Appendix A – Summary Response Table

Table 1 Summary of Issues

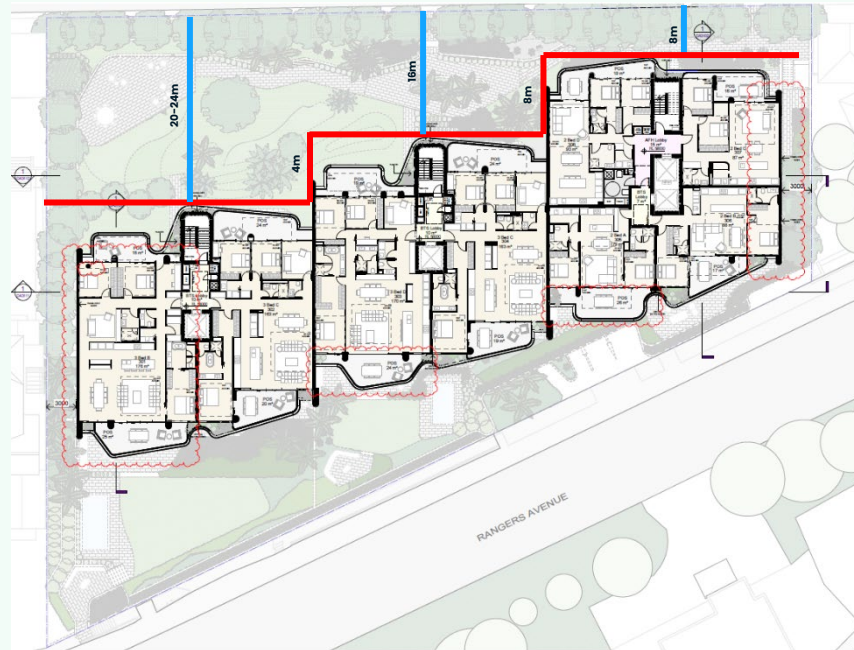
3. The proposed building lacks facade articulation and presents as a singular and dominant mass that will be incongruous with the character of the surrounding residential context, in particular to the north, where the site adjoins Holt Estate Heritage Conservation Area (not within the Low and Mid-rise (LMR) housing area). The Department is concerned that no transition in scale is provided to the surrounding lower scaled developments and heritage significant areas to the north. The lower ground level, while not being counted, presents as an additional storey to the public domain and contributes to perceived height and scale. Cumulatively, the proposal does not address the desired local character of the area as required by Chapter 4 of the State Environmental Planning policy (Housing) 2021 (Housing SEPP).

Consequently, you should consider options to further articulate the building facades fronting Rangers Avenue and Bloxsome Lane to reduce the perceived bulk and scale of the buildings. This may include opportunities for:

- reducing continuous façade lengths, separating envelopes where possible
- incorporating recesses that can be visually perceived from the public domain
- adding further façade articulation, a variety of materiality and architectural expression to break down the strong horizontality

<u>Built Form & Character:</u>	The northern façade is highly articulated into three separate modules. The base build has recesses of 4m and 8m between the blocks, as shown below.	RTS Appendix C, D, E and F

In addition to the stepping of the base building, the balconies have been designed and curated to be of different shapes and sizes to provide for visual interest and as a measure to avoid direct overlooking. The design incorporates landscaping between the balconies, which wraps around the encased service stair. At the upper level, the glazing line of the façade is further recessed, providing for reduced building form.

Comparative to a standard block form, the proposal provides for a superior urban design response, with deep recesses, variations in setbacks and variation in balcony orientation, form, shapes and sizes. The combination of measures used in addition to the materiality palette provides a skilful urban design response to the north.

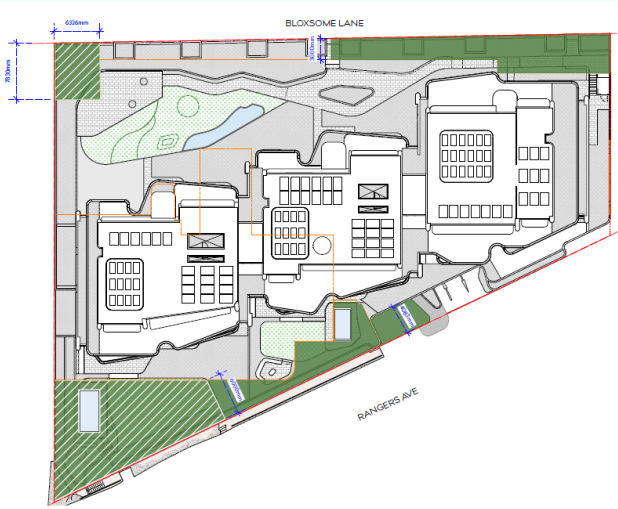
• carparking spaces in the diagram • swept paths showing that columns within the porte cochere will not compromise vehicle movements in these areas.		
<u>Landscaping & Deep Soil</u> 11. Recalculate the deep soil provisions (section 3E) consistent with the ADG definition, excluding (as a minimum): a. built and hard paved areas b. landscaped areas less than 6 m in width. 12. Provide an amended landscape area compliance plan to demonstrate that 30% of the site is landscaped as required by section 19(b) of the Housing SEPP, given that parts of the landscaped areas are compromised by hard stand structures and retaining walls. 13. Clarify how the proposal meets the Tree Canopy Guide for the LMR housing guidelines, noting that large, mature trees of good health in deep soil zones are proposed to be removed and replaced with smaller trees. 14. Provide additional landscape plans indicating the planting areas, their soil depth and volumes and the soil volume/depth relationship to proposed species and plant sizes to ensure ongoing viability of proposed landscaping. 15. Explore opportunities to provide mature tree planting along Rangers Avenue to breakup visual	The updated Landscape Plans have been provided by Wyer & Co in Appendix M, in response to the DPHI requirements for Landscaping and Deep Soil. <u>11. Deep Soil Provision (Definition)</u> Deep soil provisions have been re-calculated as per the ADG definition, excluding built and hard paved areas and landscaped areas less than 6m in width. The proposed design has also been revised to increase the amount of Deep Soil Area within the site. The deep soil area with 6m minimum horizontal dimension is 292m² which is 8.1% of site area and greater than the 7% required in accordance with the with the ADG, confirming that the proposal satisfies the requirements. <u>12. Landscape Area Compliance</u> The proposal will achieve 2057m² of landscaped area (57.2% of site area) which is greater than 1078.2m² (30% requirement) according to the section 19(b) of the Housing SEPP. Therefore, the proposal complies. <u>13. Tree Canopy Guide for LMR Housing Guidelines</u> The proposal meets the Tree Canopy Guide from LMR Housing Guidelines. The site area is 3,594m² and the total tree canopy achieved is 790.4m², which is 22% of the site area, exceeding the 20% minimum tree canopy requirement on the Tree Canopy guide.	RTS Appendix M

Proposed Deep Soil Area with 3M minimum horizontal dimension is 584², which is 16.2% of the site area, greater than the 15% required in the Tree Canopy Guide.

According to the Tree Planting Rate, 14 medium trees and 7 large trees are required in the Deep Soil Area. This clause is satisfied as 15 medium trees are proposed within the deep soil area, which is greater than the 14 medium trees required.

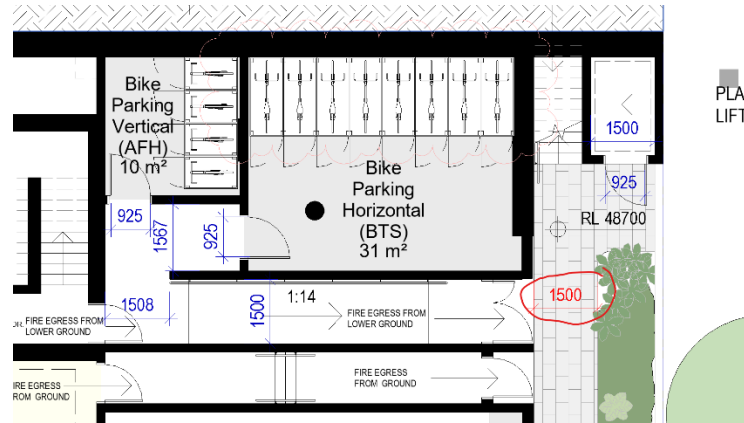
<u>12. Bicycle Parking Provisions</u> - AS2890.3:2015 requires 20% of bicycle parking to be ground-level horizontal parking, Council recommends the proposal to exceed minimum horizontal - Access to bicycle parking areas have not been adequately considered, including: 800mm width bicycle room doors being too narrow, 1.5m accessway not maintained on all section of the necessary travel paths, access corridor prior to the bike room showing a step.	The bicycle parking layout has been amended in accordance with Council's advice to include 8 horizontal bike parking spaces. In the amended layout, 60% of the bike parking spaces will be horizontal bike parking, ensuring that the proposal exceeds the 20% minimum requirement in accordance with AS2890.3:2015. This further encourages cycling to Cremorne and Spit Junction Centres within comfortable cycling distances. Further amendments have been made to the proposed access to the bicycle parking areas. As shown on Sheet DA2010 of the Architectural Plans, bicycle room doors are designed with a clear width of 925mm, exceeding Council's nominated width of 800mm. Minor landscaping adjustments, including a 270mm widening, are proposed in the current amendments along the accessway to provide a 1.5m wide approach to the bicycle parking room, allowing adequate space for bicycle manoeuvring. No steps are proposed within the accessway; instead, a ramp with a maximum gradient of 1:14 is provided. It should be noted that the previous drawing referenced	RTS Appendix E

tactile indicators, and no steps were ever proposed. The drawings have now been updated to avoid confusion; Accordingly, the proposal achieves compliance with the BCA.
